CLAREMONT BUSINESS PARK FILING NO. 3

GRADING AND EROSION CONTROL PLAN

El Paso County PCD File No.: SF-20-014

GRADING & EROSION CONTROL PLAN
CLAREMONT BUSINESS PARK FIL. NO. 3
JOB NO. 44-037
DATE PREPARED: APRIL 28, 2020
DATE REVISED:

URBAN LOCAL CROSS SECTION (PRIVATE)

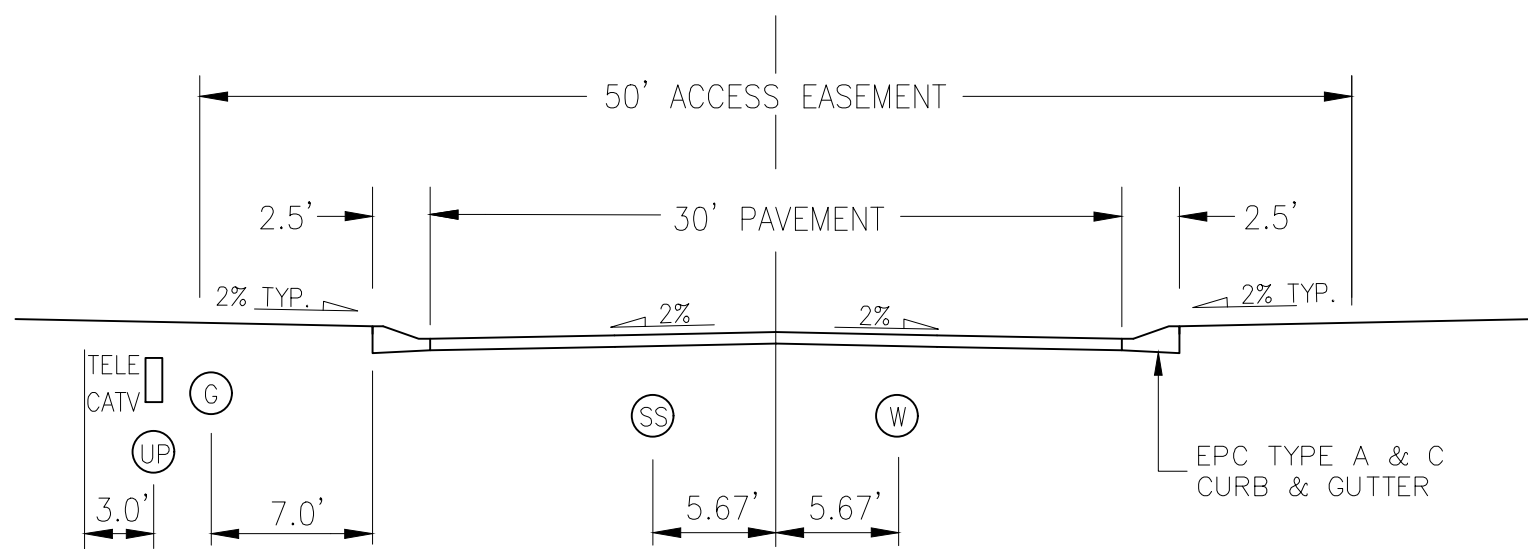
Item 17a & 17c - if same as Construction Site Boundaries, label as such

Add Concrete Washout to Legend and show proposed location on plans (even though SWMP says that the location will likely change)

Add Mulching and Seeding to Legend and show on plans

Add Temporary Stockpile Location to Legend and Plans

Item E - Show property lines on Legend and Plan

Item EE - Shown easement linetype on Legend

Does not match soils report referenced in the SWMP.

Item O - Are these disturbances onsite or offsite?

IP-1. BLOCK AND ROCK SOCK SUMP OR ON GRADE INLET PROTECTION

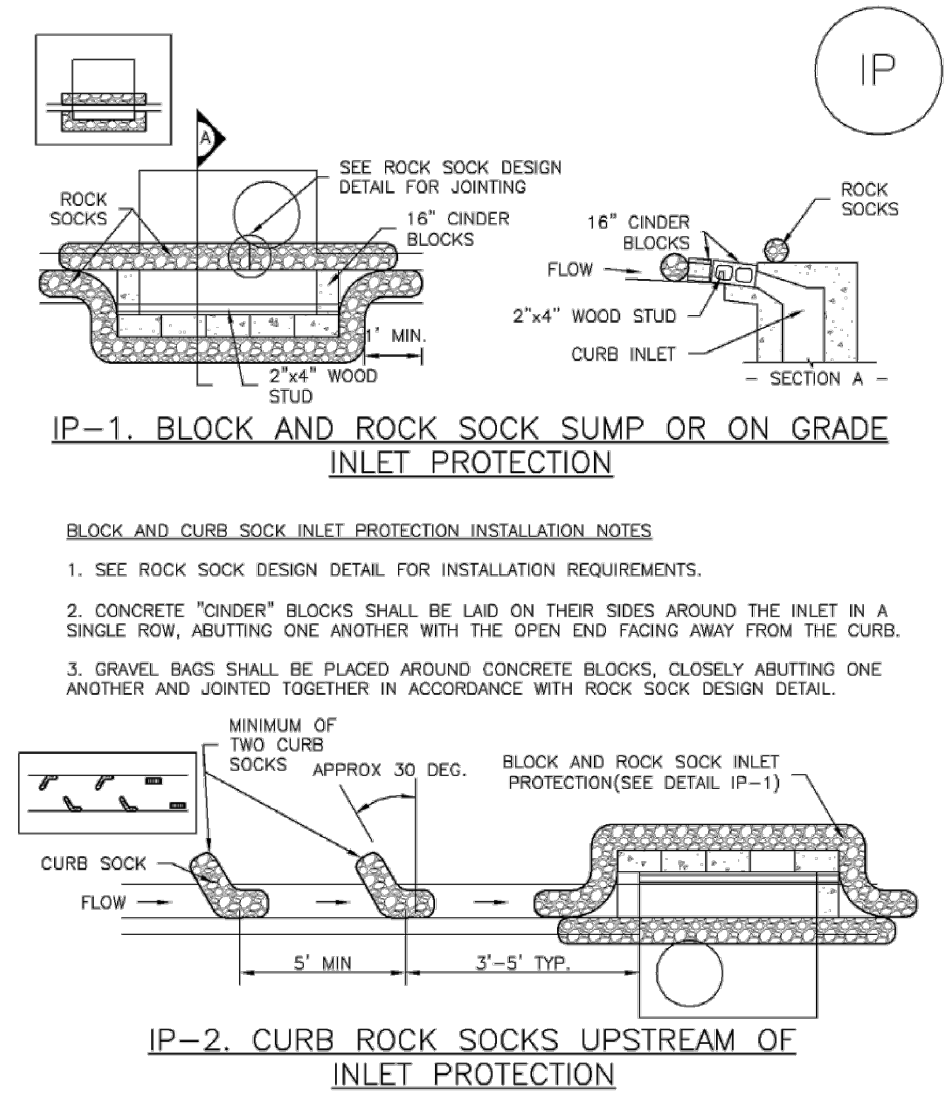
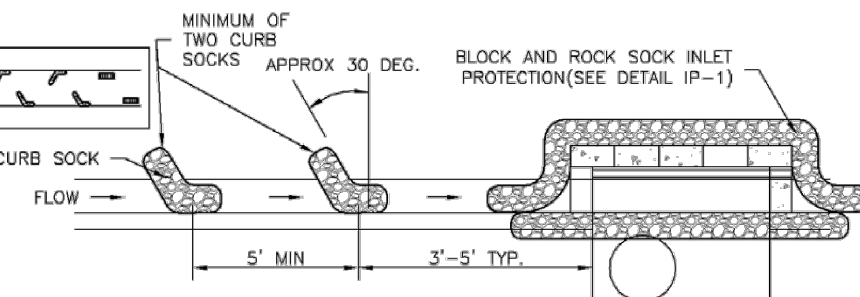
Item 20 & Z - Add details for:
- Straw Bale Checks
